HL-4865

Edwin I. Hatch Nuclear Plant  
Response to Second Request for Additional Information:  
Power Uprate

Edwin I. Hatch Nuclear Plant  
Response to Second RFAI  
Power Uprate Submittal

Figure 7-4. Transition Temperature Shift Based on Surveillance Specimen Test Results

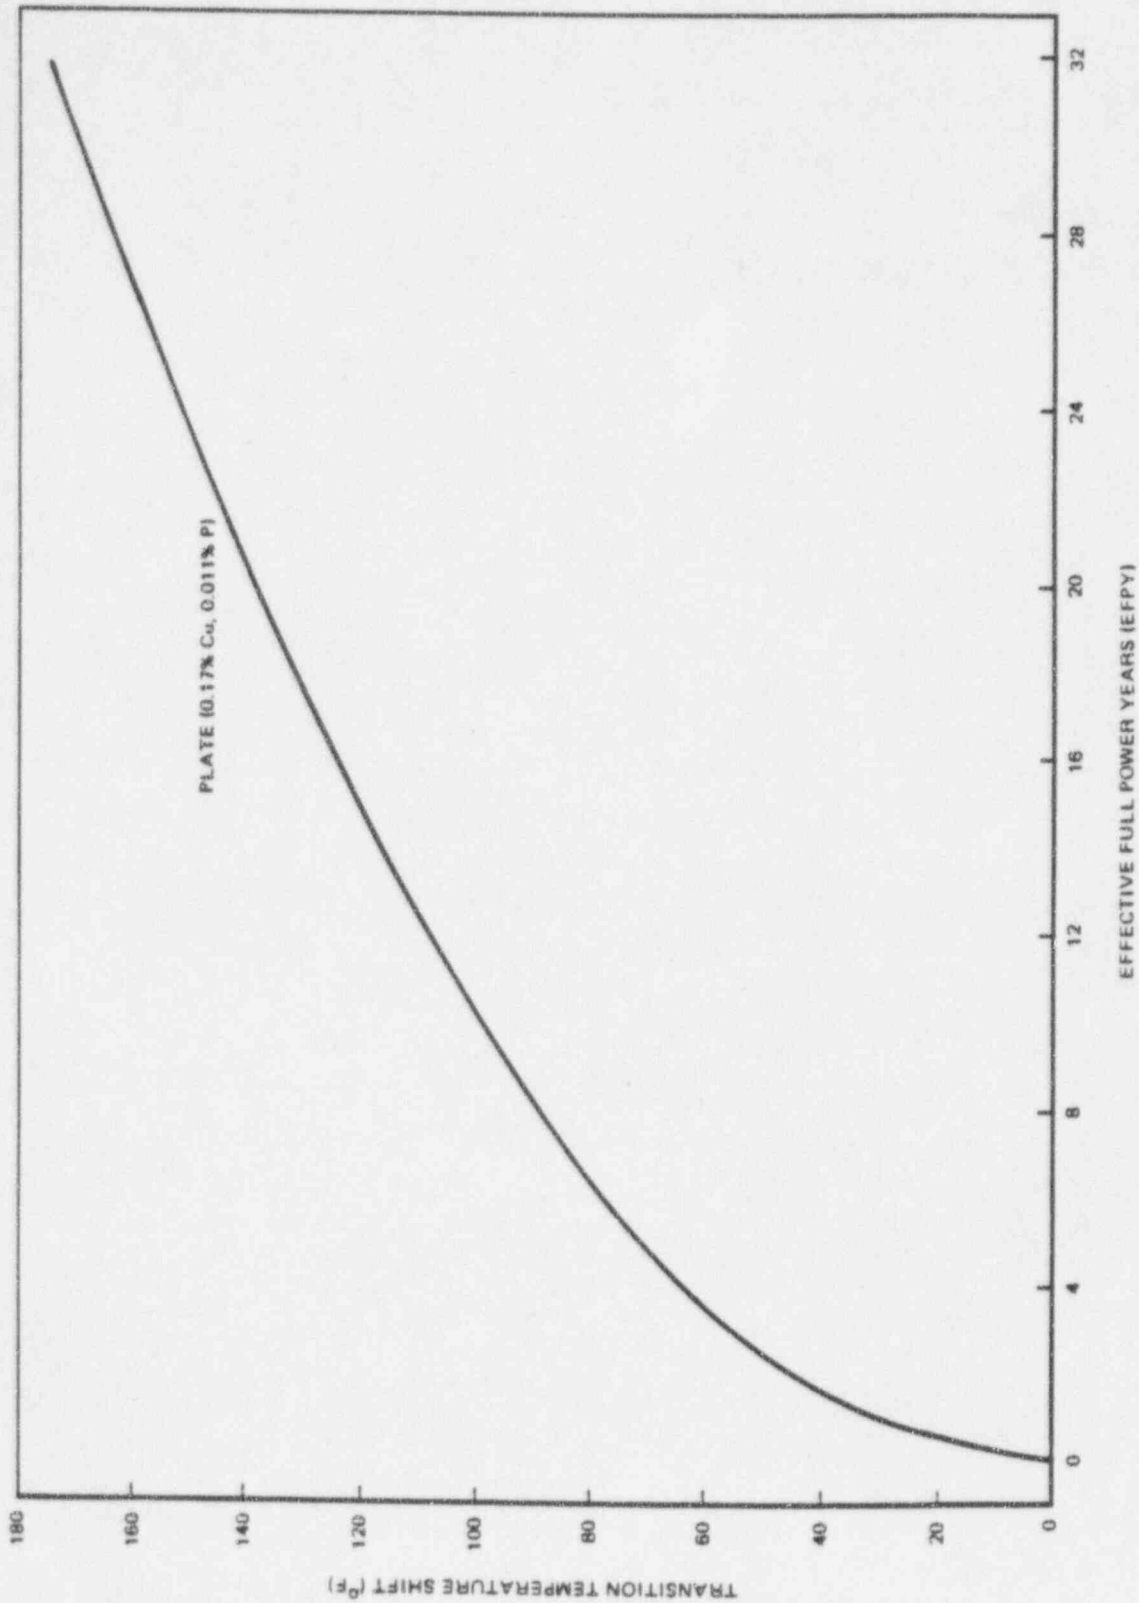
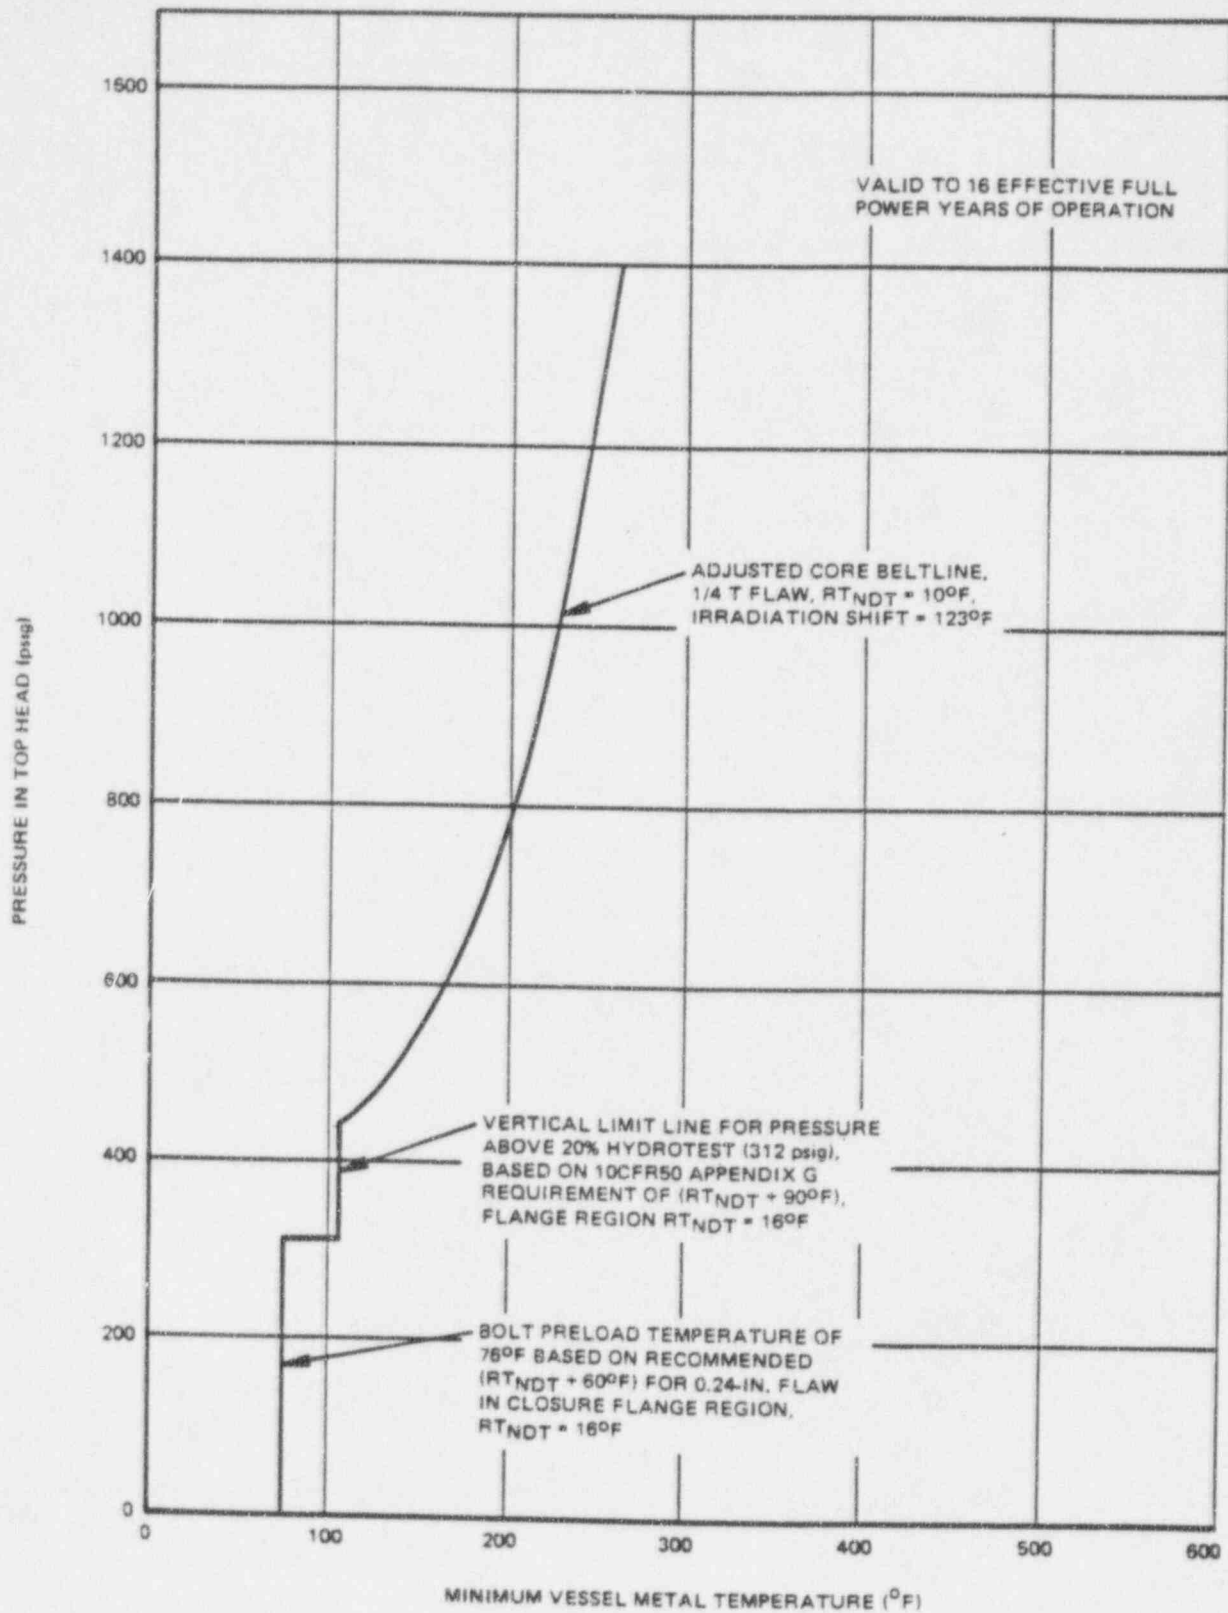
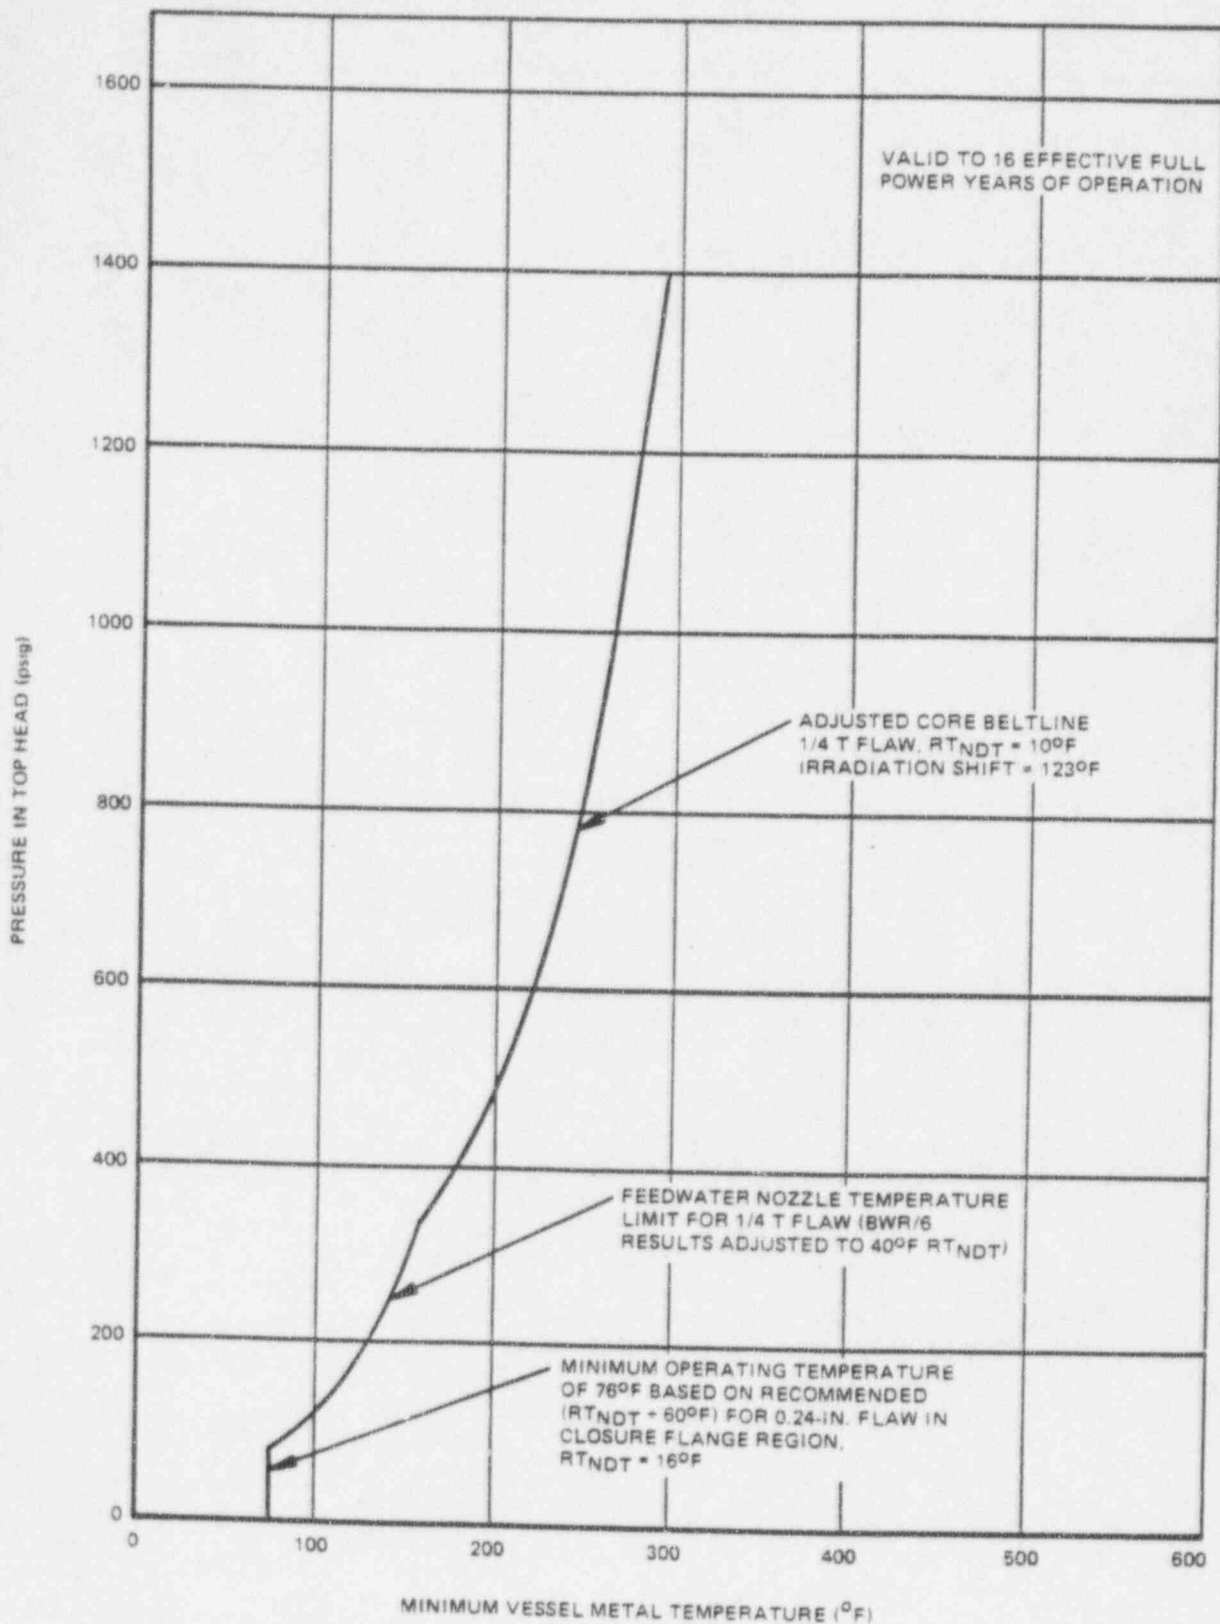
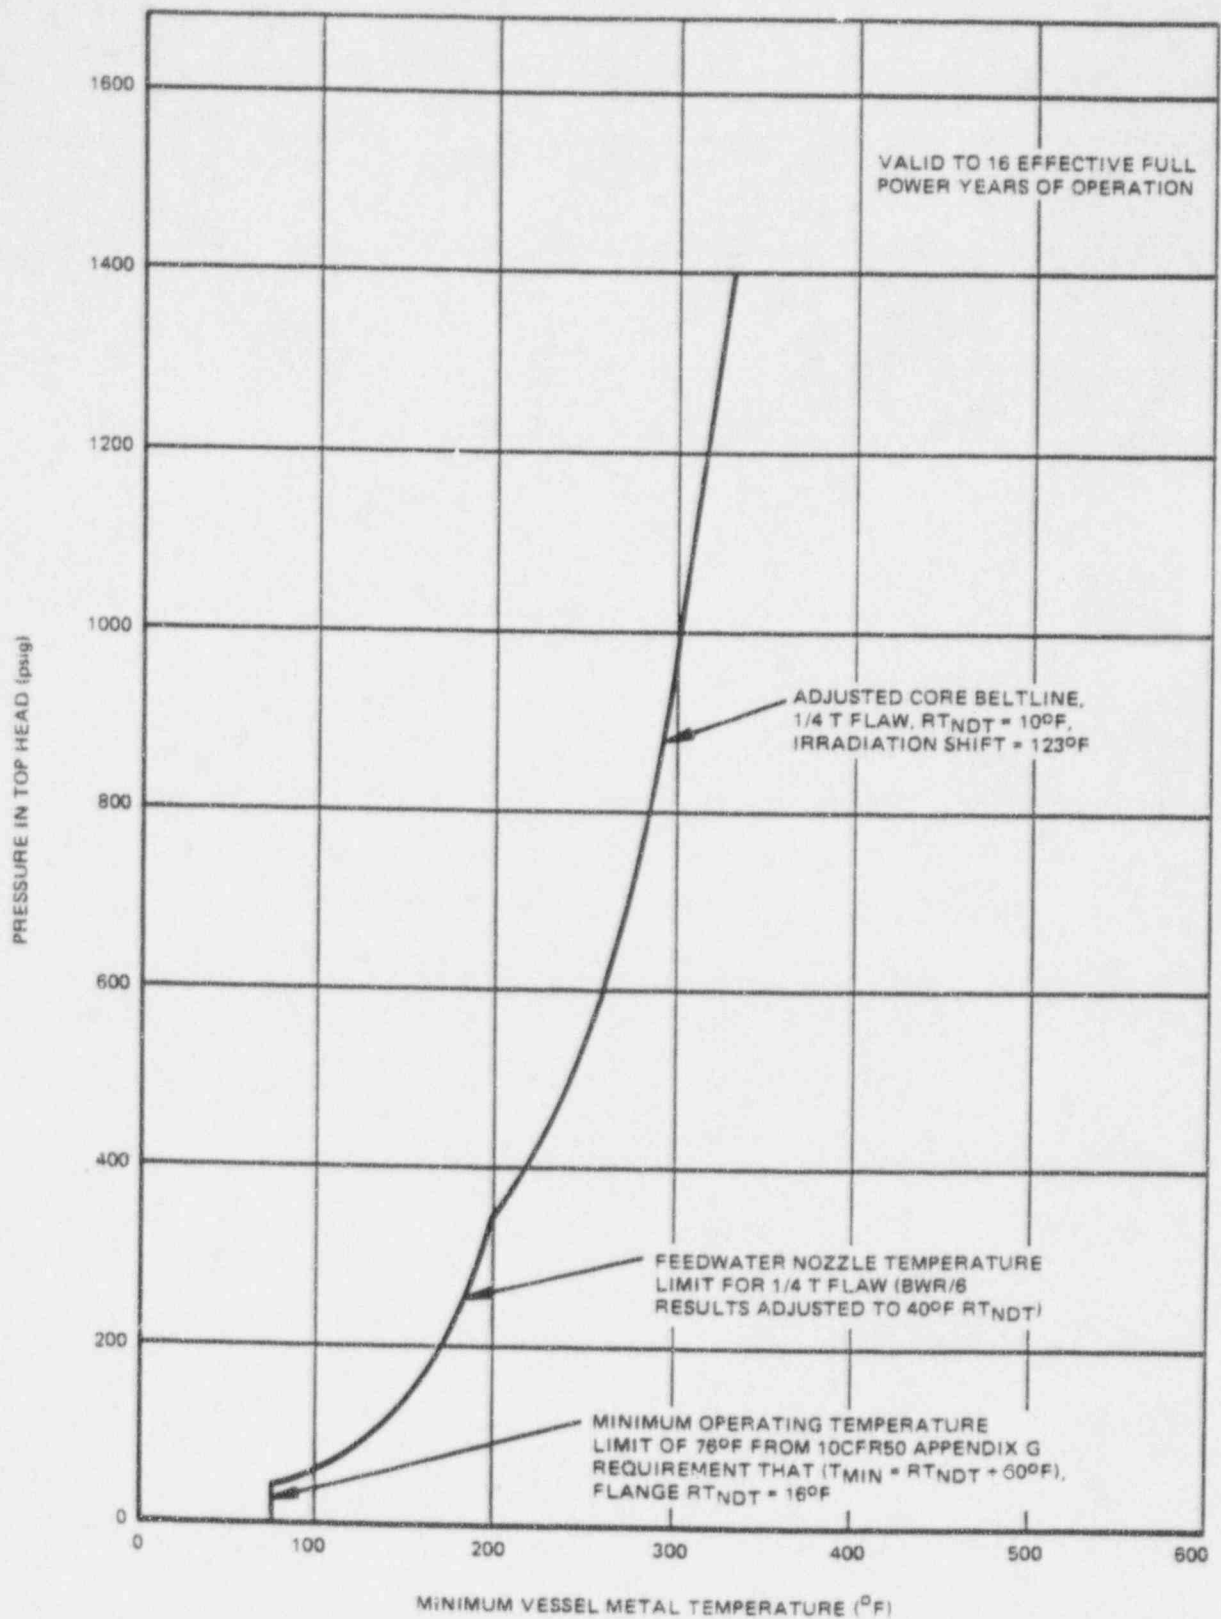
Provide detailed calculations to show how ART of 132° F for the uprate case and 133° F for the current P-T limits were derived for Hatch Unit 1.

The 133°F calculations were submitted to the NRC in GPC letter SL-189, dated January 10, 1986. This GPC submittal provided GE Report NEDC-30997, "Edwin I. Hatch Nuclear Power Plant, Unit 1, Reactor Pressure Vessel Surveillance Materials Testing and Fracture Toughness Analysis," October 1985. The NRC reviewed this report and approved the Unit 1 P-T curves as Amendment 126 to the Unit 1 Technical Specifications. Pertinent pages of NEDC-30997 are provided in Attachment A to this enclosure.
